Engine Harness Changes
D11J, D13J
VAH, VHD, VN

FSB 284-056, Engine Harness Changes

(April 2015)

W2100467

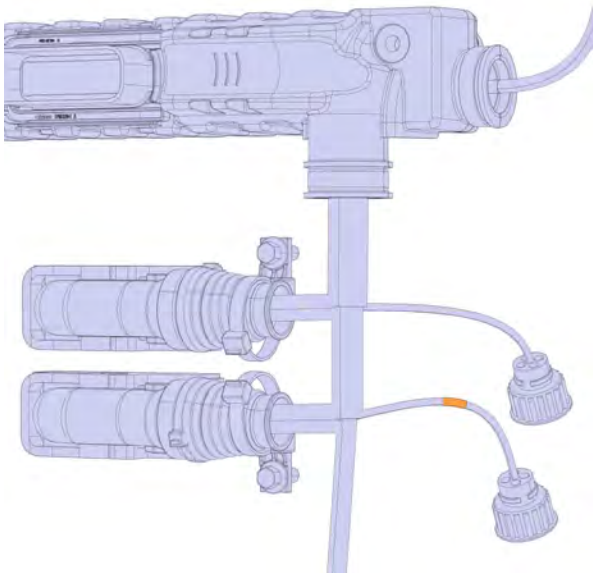
- D13 Engine Only: Yellow marking tape added to crankcase pressure sensor wire. Blue marking tape removed from oil pressure sensor wire.

W2100052

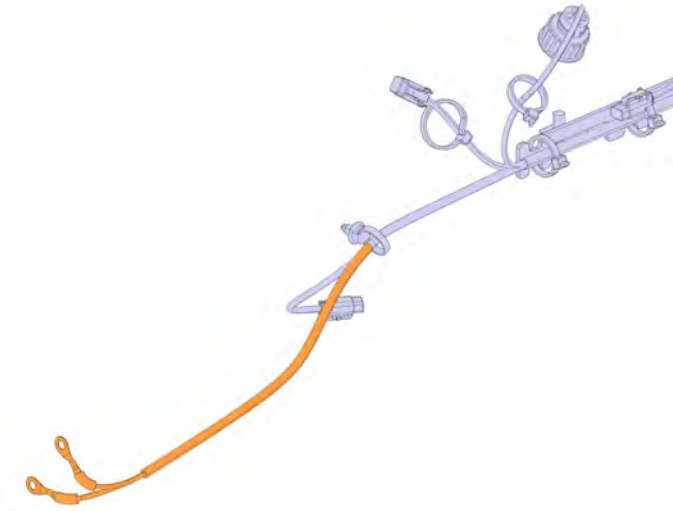
- The starter solenoid wires now come from the front. Previous starter wire routed around the cold side of engine around the rear.

W2100055

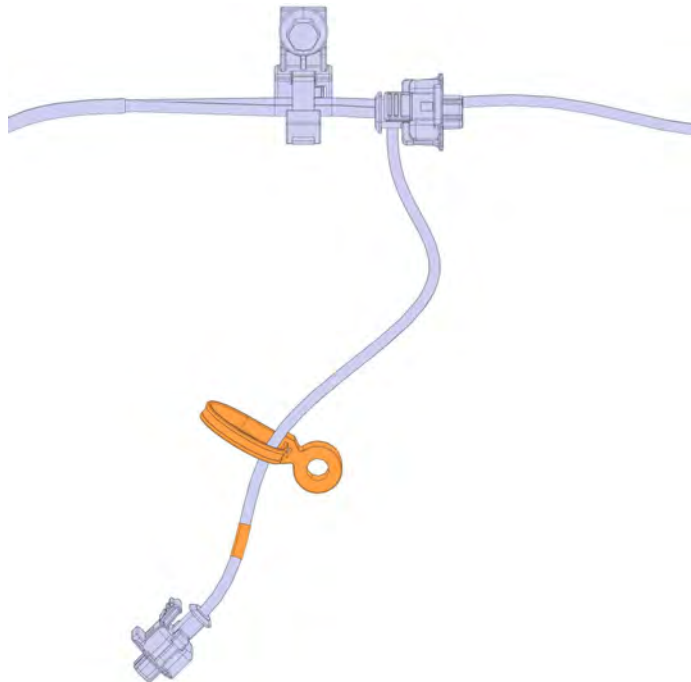
- D13 Engine Only: Crankshaft speed sensor has yellow marking tape on it so it is not confused with EGR valve sensor. Stud-mounted cable tie added.
